SUBJECT: Transmittal of Westinghouse Response to Boron Precipitation during LTC Phase

“Boron Precipitation During LTC Phase”

AP1000 DESIGN CERTIFICATION REVIEW

DSER Open Item Number: None Assigned, See Below

Figure 3 – Vertical Flow Regime Map (Taitel-Dukler)

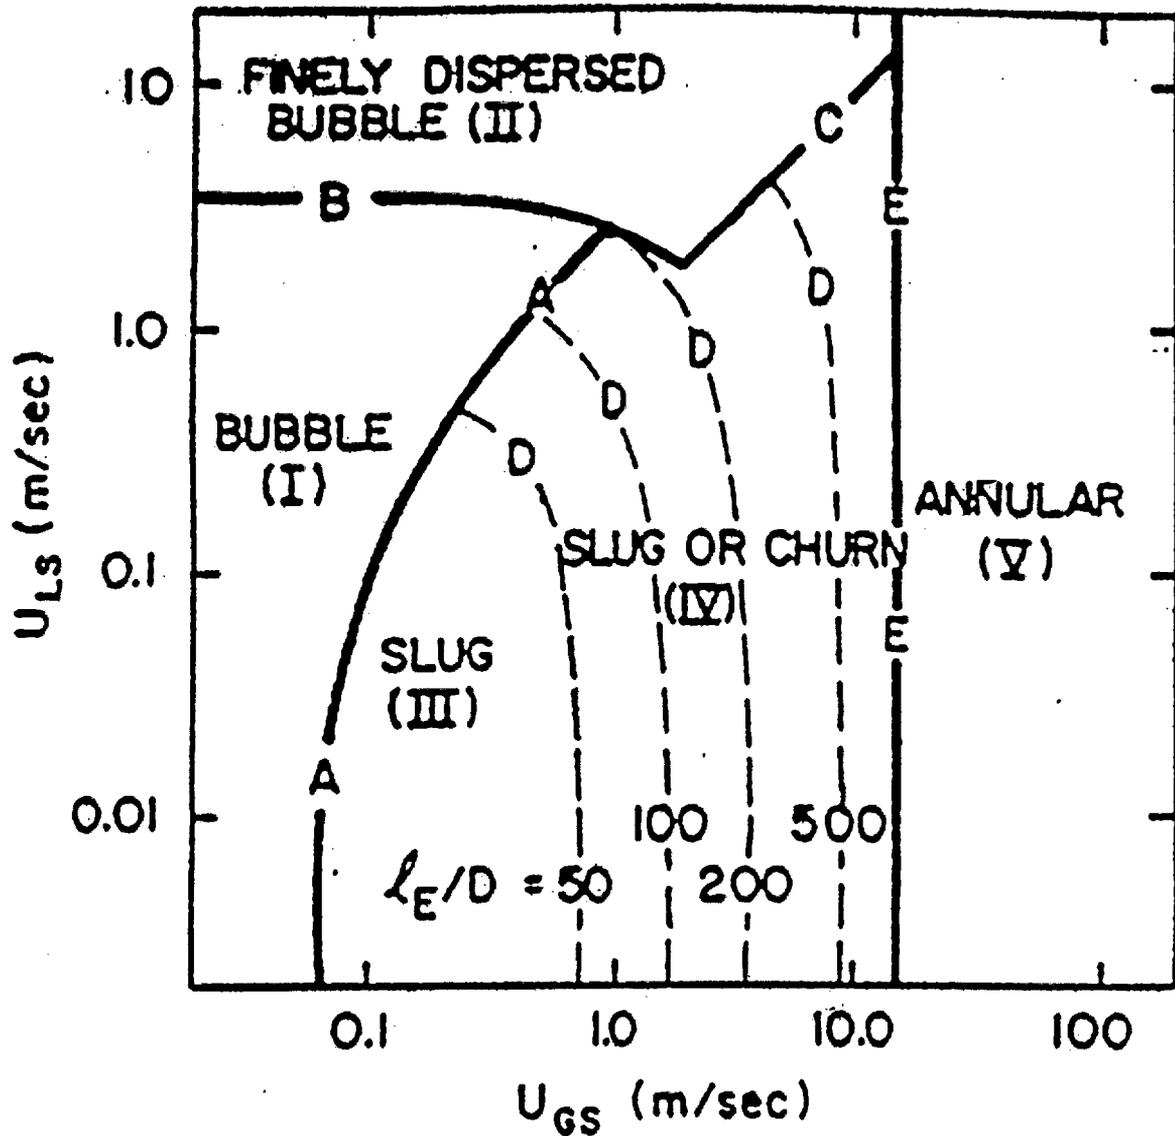
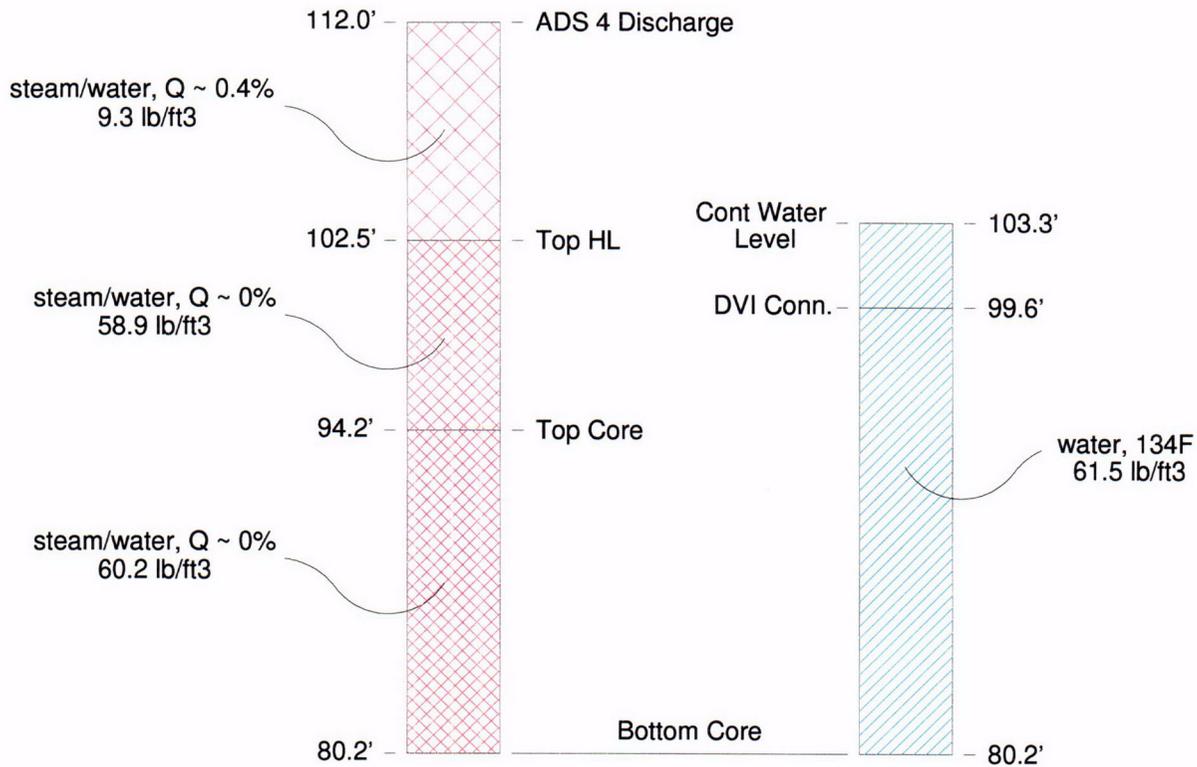
Westinghouse should also address the possible collection of boric acid crystals on the ADS-4 valves and exit piping as these equipment components cool during the event. Justification should be provided to discount the possibility for the ADS-4 valves/piping to become obstructed with boric acid crystals many hours into the event.

10. The 2-phase flow regime is determined at the entrance to the ADS 4 lines where they connect to the HL. This location is considered limiting because the orientation is vertical with upward flow and the velocities at this point are less than those in the individual ADS 4 lines. As a result, if the water can be lifted into the ADS 4 inlet the water will be more easily

pushed out the individual, horizontal ADS 4 lines. The Taittel-Dukler vertical flow regime map (Figure 3) is used to determine the flow regime in the ADS 4 inlet lines.

For each analysis, the ADS 4 vent quality and the flow regime at the inlet to the ADS 4 line is shown in Table 4. For the maximum quality set, the ADS 4 flow regime is annular out through 14 days and then changes to slug/churn. For the best estimate quality set, the ADS 4 flow regime is annular out through 1 day, is slug/churn out through 14 days and then changes to slug flow. The minimum quality set has bubble flow from early on; the main driver for this is the very low decay heat assumed (just after refueling).

For the maximum and best estimate sets, the flow regime (annular, slug/churn, slug) is sufficient to move the water out the ADS 4 flow path. However, for the minimum set it is not obvious that bubble flow can move water out the ADS 4 vent.

Figure 5 – AP1000 Post LOCA Boron Concentration

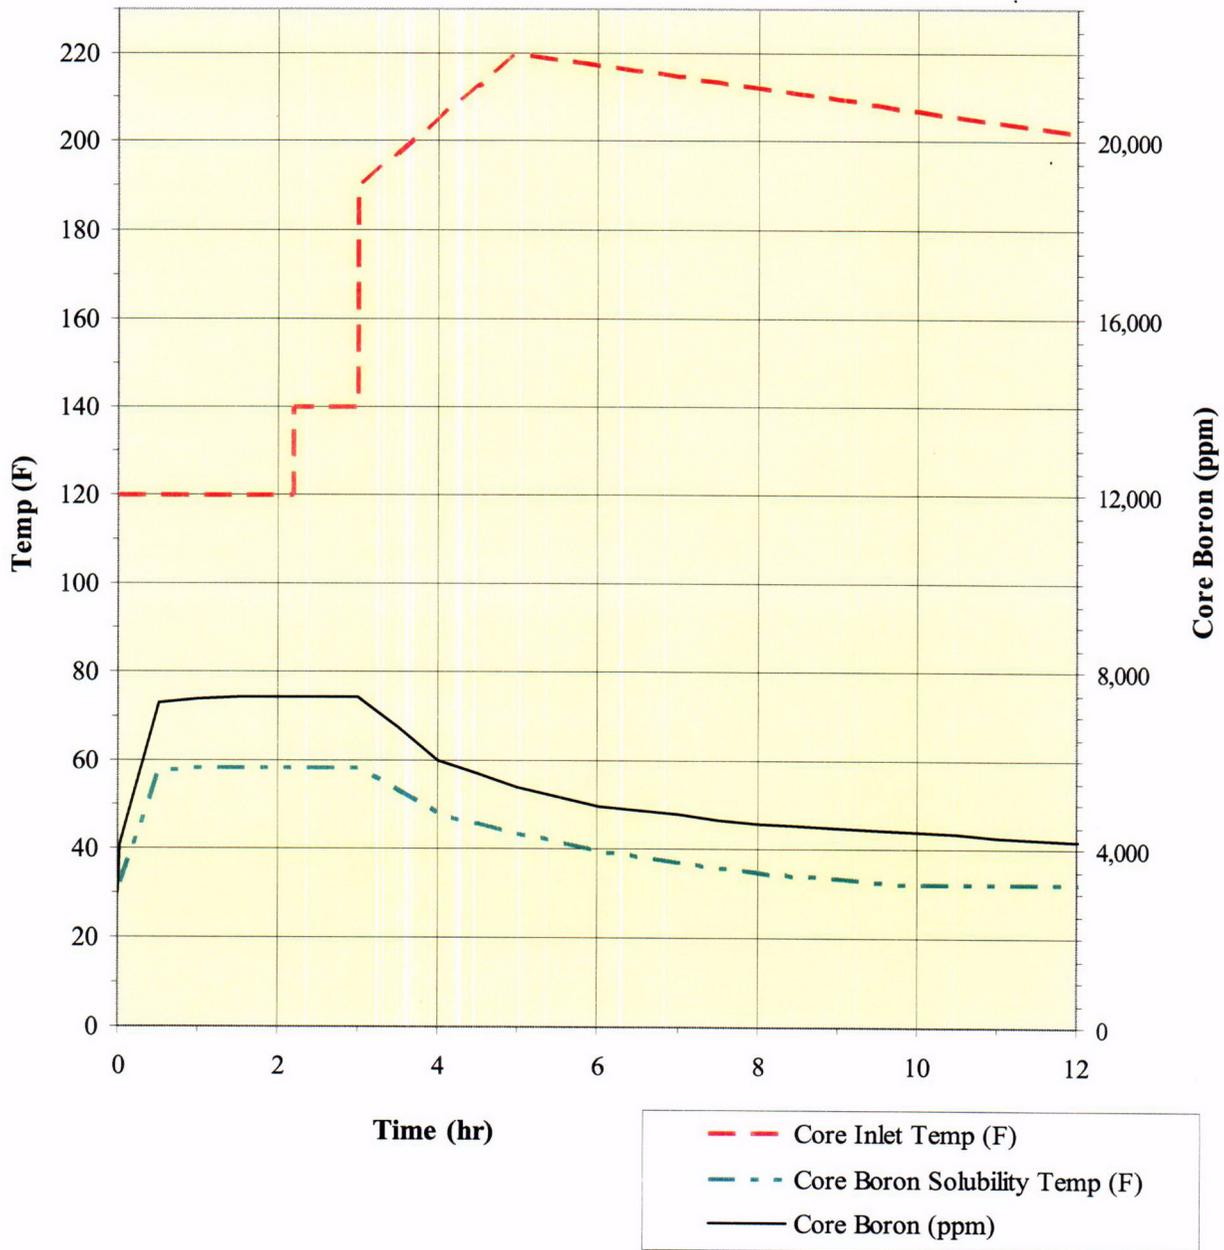
As the core cools, the increase in coolant boric acid concentration is arrested. However, a high boric acid concentration remains in the core many hours into the event. Westinghouse must demonstrate that as the core becomes increasingly subcooled, these high boric acid concentrations will not result in boron precipitation in the core and that the analysis takes into consideration the effect of coolant temperature on boron solubility. Westinghouse should also demonstrate that the concentrations in the sump also do not approach precipitation limits at the maximum sump temperature subcoolings.

The core concentration starts at about 2980 ppm and reaches a maximum value of 7400 ppm in about 2.4 hours. By 6 hours the concentration has dropped below 5000 ppm. Figure 5 shows the calculated AP1000 core boron concentration as a function of time. This figure also shows the solubility temperature of the boron solution in the core. When the core is at its maximum concentration of 7400 ppm the solubility temperature is 58 F. The core inlet temperature will be well above this temperature based on several considerations.

The maximum core boron concentration will be less than 7,400 ppm using the maximum ADS 4 vent quality and the maximum initial core / containment boron concentrations. This core boron concentration is far below the solubility limit (35,000 ppm). In addition, the solubility temperature (58 F) at the maximum boron concentration is significantly lower than the minimum core inlet temperature (120 F). In addition, the core boron concentration quickly drops to lower values (less than 5000 ppm in 6 hours) which further increases margin.
